CITY PLANNING COMMISSION

APPLICATION: A. Negative Declaration
B. Plan Review for the construction of a 51,000 square foot office/warehouse building on 8.96+ vacant acres in the Heavy Industrial Review (M-2(S)R) zone.

LOCATION: Northeast corner of Wayne Court and Elk Grove-Florin Road

P89-200

TH HNT
 PRELIMINARY LANDSCAPE PLAN
 SHEET TITLE

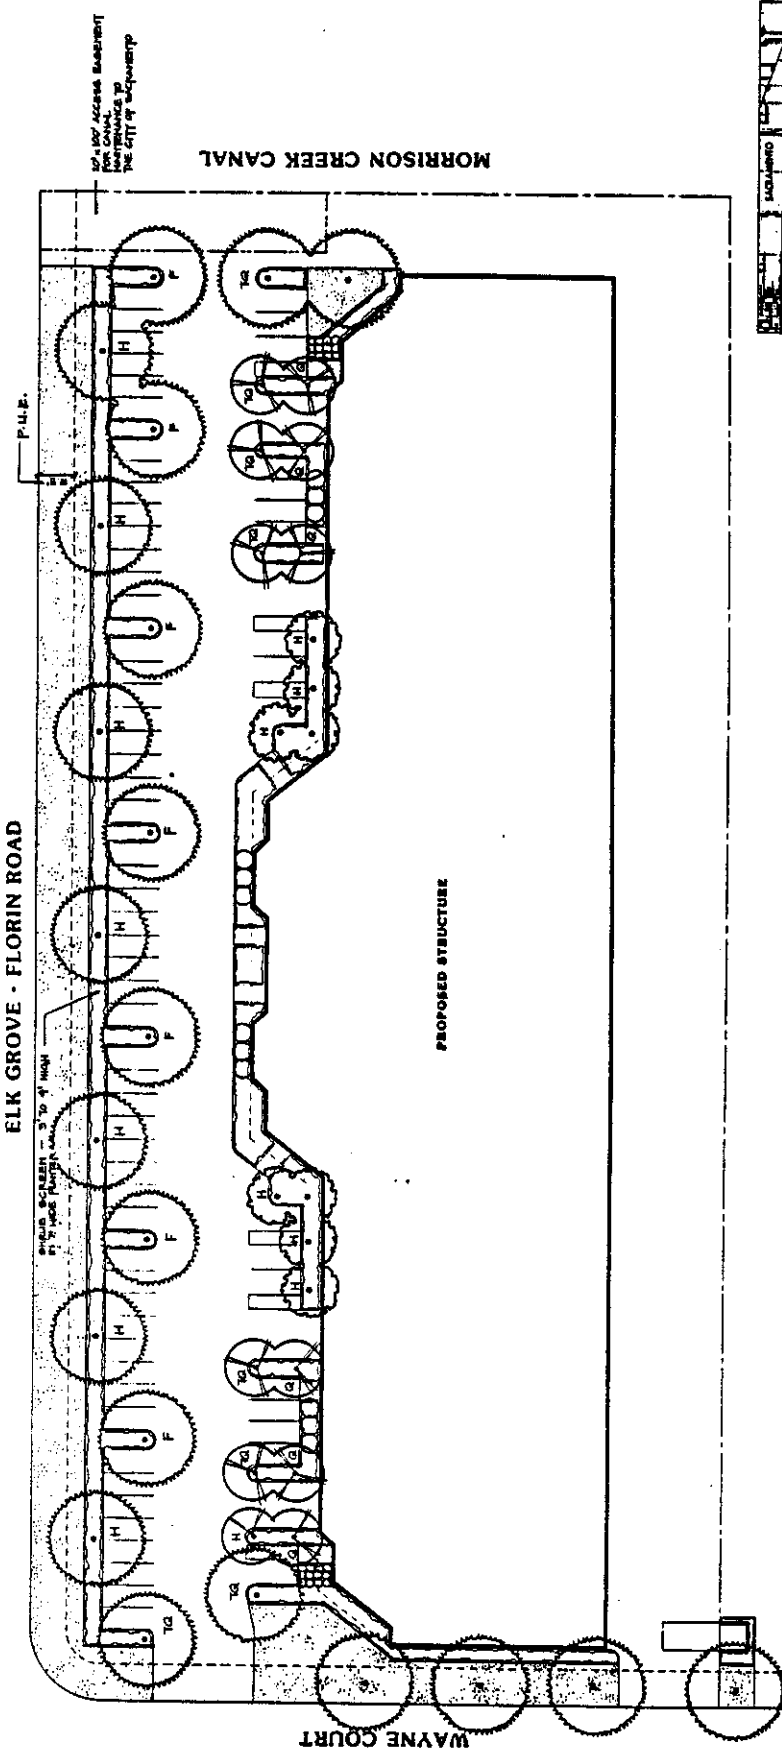
A landscape plan was submitted. The plan indicates 15 gallon trees along the north, west, and south property lines. Three and four foot high shrubs are identified on the plan to screen the parking. Staff recommends that the applicant provide 3 1/2 foot high undulating berms along Wayne Court and Elk Grove-Florin Road. The landscape setback shall consist of lawn material in the 25 foot setback along both Wayne Court and Elk Grove-Florin Road. One and five gallon shrubs and ground cover are proposed along the perimeter of the building on the west and south sides.

1. The applicant shall redesign the site plan to the satisfaction of the Planning Director prior to issuance of building permits. The revision shall include increasing the landscape setback along Wayne Court to 25 feet.
2. The 25 foot landscape setbacks along Wayne Court and Elk Grove-Florin Road shall consist of lawn material and trees.
3. The applicant shall submit a letter of approval from the County of Sacramento approving access off of Elk Grove-Florin Road prior to issuance of building permits.
4. All signage proposed on the structure or site shall be subject to review and approval by the Planning Director prior to issuance of a sign permit.

EXHIBIT C ELEVATIONS

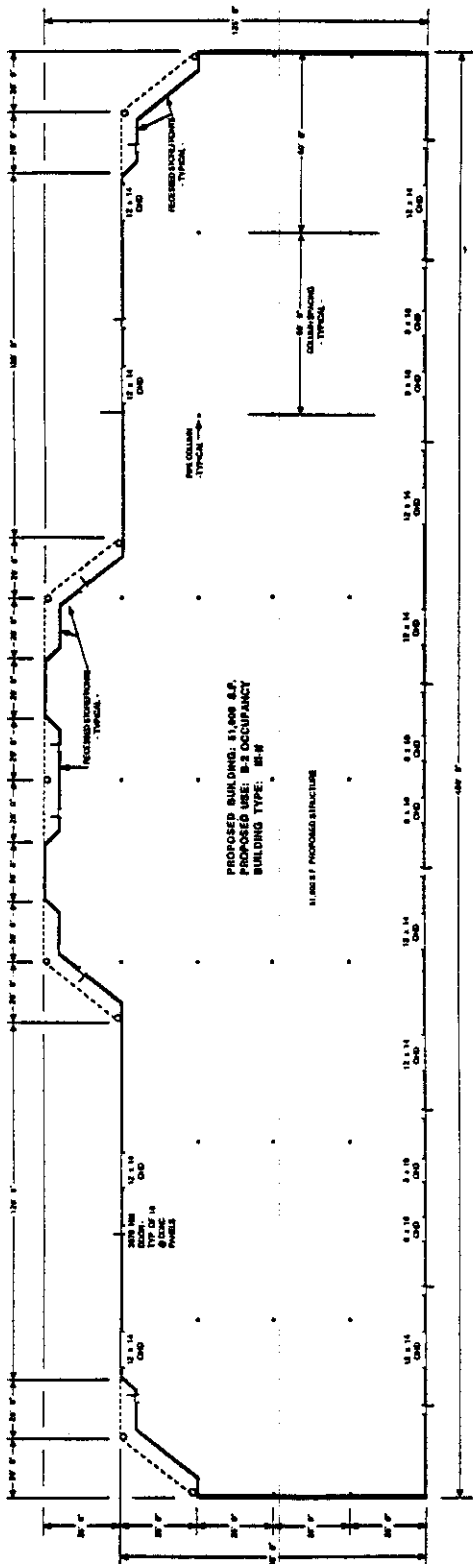
The proposed building materials are precast concrete panels with brick veneer. Roof material is a plywood built-up roof. The building is a 22 foot high, one-story structure. Staff has no objection to the proposed building material. The brick veneer and recessed glass front compliments the overall appearance of the structure.

No signage has been indicated on the proposed site plan or elevations. Any signage proposed on the structure or site shall be subject to review and approval by the Planning Director prior to issuance of a sign permit.
